RotorSport UK Ltd Service Bulletin (Permit)

Title: RSII rotor interchange		
SB-116 Iss1	Related documents Modification: MC-175, MC-328 CCAR No.: None	Compliance Category: OPTIONAL or RECOMMENDED or MANDATORY
Applicability		
Aircraft type & model: MT-03 MTOsport Calidus Cavalon	Aircraft serial Nos. affected: RSUK/MT03/any RSUK/MTOS/any RSUK/CALS/any RSUK/CVLN/any	
The maintenance manual to be referenced is this stated or subsequent issue.		RSUK0012 Iss 12 (MT-03) RSUK0044 Iss 9 (MTOS) RSUK0061 Iss 7 (Calidus) RSUK0288 Iss5 (Cavalon)
<p>This form is the response from RotorSport UK Ltd either against a problem found in the product in service requiring a containment or rectification action, or as service information for aircraft modification incorporation. For help, contact RotorSport on 44(0)1588 505060, or email compliance@rotorsport.org.</p> <p>The technical content of this document is approved under the authority of the UK CAA Design Organisation Approval Ref: DAI/9917/06</p>

Under this service bulletin SB-116 gyroplanes already fitted with RotorSystemII standard variant rotor (red end caps) may be fitted with RotorSystemII TOPP rotor (blue end caps). Alternatively, gyroplanes al

RSII rotor head installation of MTOsport (MT-03 is very similar)

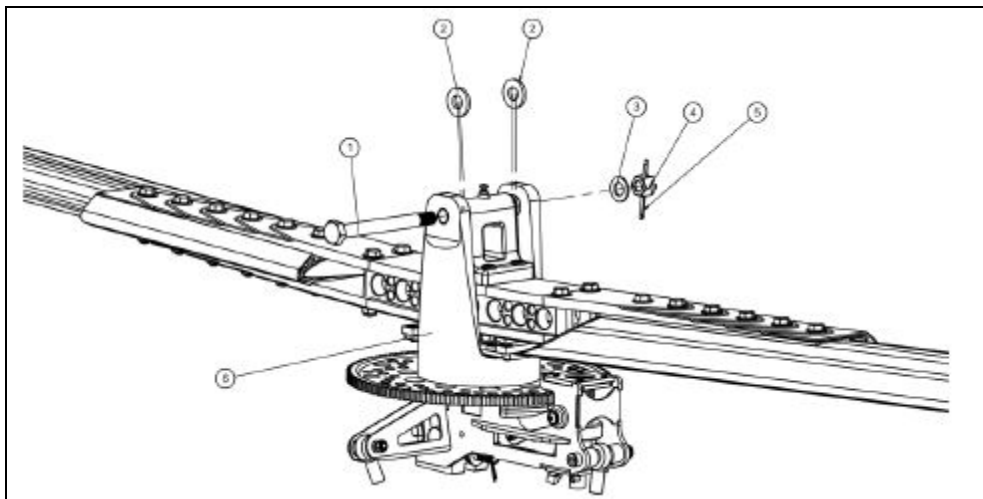
If the gyroplane is fitted with RotorSystemII either the standard variant rotor (red end caps) or the TOPP-variant rotor (blue end caps) may be fitted. Each rotor assembly is furnished with two shim washers which are selected during initial rotor balancing (Item 2 in schematics below), and these must be retained with the correct rotor assembly. Other than this restriction the two rotor variants are mechanically interchangeable as complete assemblies. Detailed instructions for rotor removal and fitment are provided in each aircraft's POH and AMM and to avoid the risk of error in duplication these instructions are not repeated here.

However, the weight of the each rotor variant differs, so affecting the weight of the aircraft and in some cases its CG. It is therefore necessary to arrange the issue of a revised Aircraft Weighing Certificate (AWC) from RotorSport UK Ltd, and then to amend or replace the aircraft's weight placard. It may also be necessary to apply to CAA for a revised Permit to Fly (use the pro-forma appended to this bulletin). The table below provides the appropriate information.

Aircraft type	Present RSII rotor	Intended RSII rotor	Weight change kg	New CG limits, mm
MT03 (450kg MTOW)	Standard	TOPP	+4.0	376 to 596 horizontally 819 to 972 vertically
MT03 (450kg MTOW)	TOPP	Standard	-4.0	376 to 596 horizontally 819 to 952 vertically
MT03 (500kg MTOW)	Standard	TOPP	+4.0	371 to 596 horizontally 814 to 972 vertically
MT03 (500kg MTOW)	TOPP	Standard	-4.0	371 to 596 horizontally 814 to 952 vertically
MTOS (HTC prop)	Standard	TOPP	+4.0	370 to 600 horizontally 770 to 950 vertically
MTOS (HTC prop)	TOPP	Standard	-4.0	370 to 600 horizontally 770 to 930 vertically
MTOS (Woodcomp prop)	Standard	TOPP	+4.0	343 to 600 horizontally 770 to 950 vertically
MTOS (Woodcomp prop)	TOPP	Standard	-4.0	343 to 600 horizontally 770 to 930 vertically
Calidus	Standard	TOPP	+4.0	255 to 485 horizontally 795 to 895 vertically (No change introduced)
Calidus	TOPP	Standard	-4.0	255 to 485 horizontally 795 to 895 vertically (No change introduced)

Cavalon*	Standard RAO	TOPP	+4.0	345 to 540 horizontally 750 to 940 vertically
Cavalon*	TOPP	Standard RAO	-4.0	345 to 540 horizontally 750 to 900 vertically
